**Fish and Wildlife Coordination Act Report**

**Navigation Improvements Project**

**Valdez, Alaska**

September 2006

Figure 4

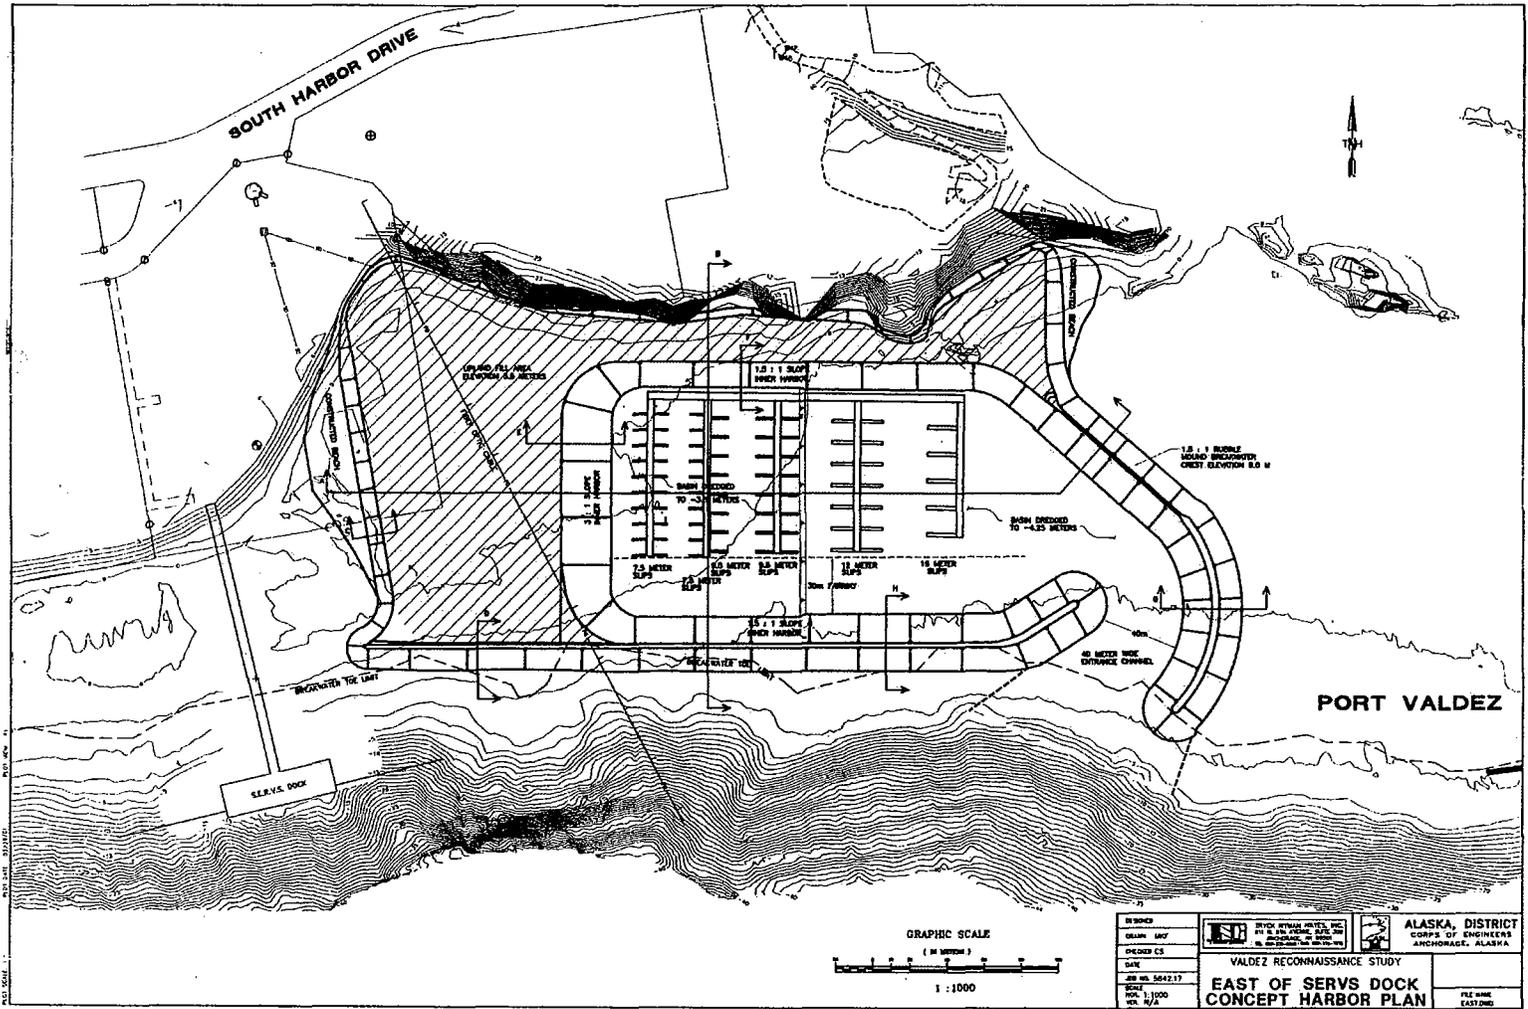
2002 (Initial) East Side Design. The proposed harbor was to include a basin of 4 ha (9.88 acres), including the entrance and maneuvering channels (Figure 4). The mooring basin was to accommodate 153 vessels ranging in size from 9 m to 30 m. The entrance channel would be 40 m wide, sufficient for two way traffic, except for the largest vessels. The entrance channel depth would be - 4.25 m MLLW and decrease to - 3.2 m at the far end of the basin away from the entrance. Basin dredging would have totaled 105,700 m<sup>3</sup>, including the entrance and maneuvering channels. Disposal was originally planned for adjacent disposal areas forming the staging area. No offshore disposal was anticipated. The dredge material was expected to consist of sands and gravels; however, large rock slabs and boulders will be present closer to Hotel Hill.

The south breakwater was designed to be approximately 390 m long, including the part by the upland fill area. The east end curved slightly to the north at the entrance channel. The east breakwater curved in a north-south direction from Hotel Hill to the entrance and was approximately 294 m long. The seaside slope of the east breakwater had a 1 vertical (V):2 horizontal (H) slope to simulate a more natural condition. The foundation materials were sands and gravels with a thin muddy layer on the surface. Foundation and stability aspects were considered good by the ACOE. The elevation of the foundation of the breakwaters varied from

Figure 9

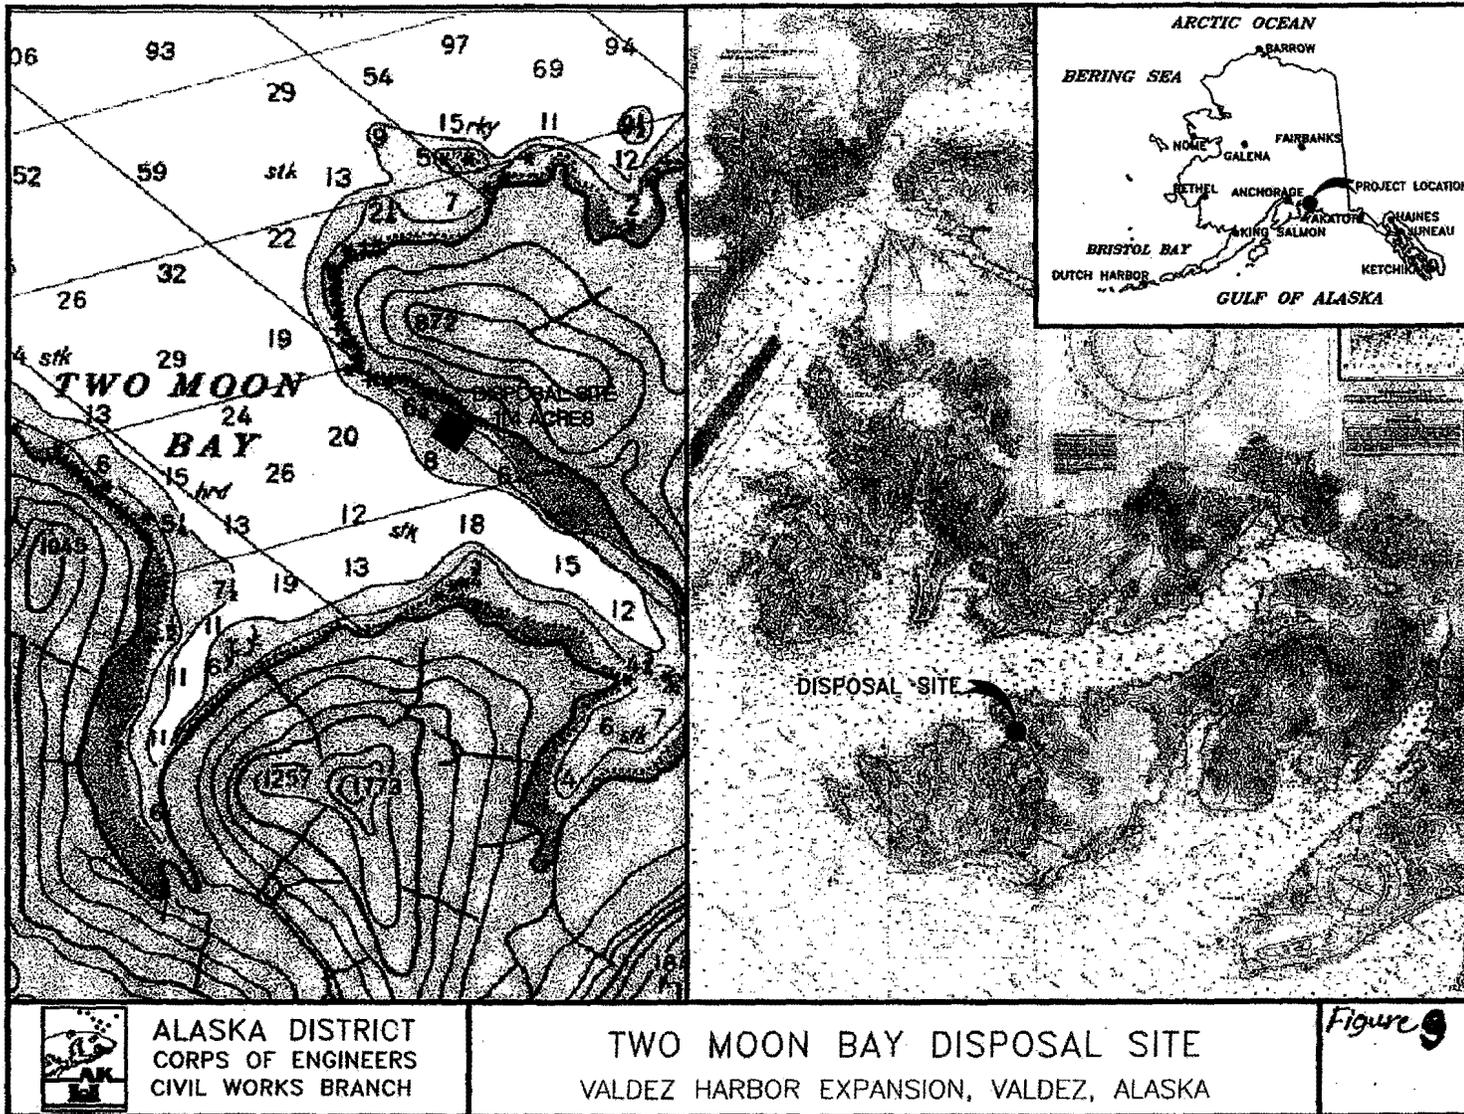
The initial phase would involve conducting bathymetric and biological surveys of Two Moon Bay (Figure 9) to determine the precise extent of the debris field, assess current and tidal patterns, and the location of existing important subtidal marine resources adjacent to the debris field (such as eelgrass beds, rocky outcropping, etc.). Secondly, as much of the existing bark field at Two Moon Bay as possible would be capped using dredge spoil from the proposed Valdez harbor expansion (Figure 10). While there may not be enough fill from harbor dredging to fully bring the debris field up to grade, the Service recommends that the restoration plan developed as part of harbor development account for this final goal. Subsequent projects in eastern PWS could provide additional fill for Two Moon Bay. Additionally, any large slabs of colonized substrate harvested from the harbor development site and not used as seed material on top of new harbor rock should be considered for moving to Two Moon Bay as part of the habitat restoration there.

Once the filled substrate is an adequate depth for eelgrass, the third phase of restoration would involve harvesting eelgrass shoots from existing eelgrass beds in Two Moon Bay and adjacent coves for transplanting on the fill. Additional habitat value and stabilization of the fill slopes might be achieved by the placement of “reef balls” in a double row around the perimeter of the project site (Figure 11). “Reef balls” are cement structures which provide habitat complexity and substrate for colonizing mussels, oysters, and marine algae. They have been effectively used as mitigation in many locations around the world and were installed near Whittier, Alaska, in
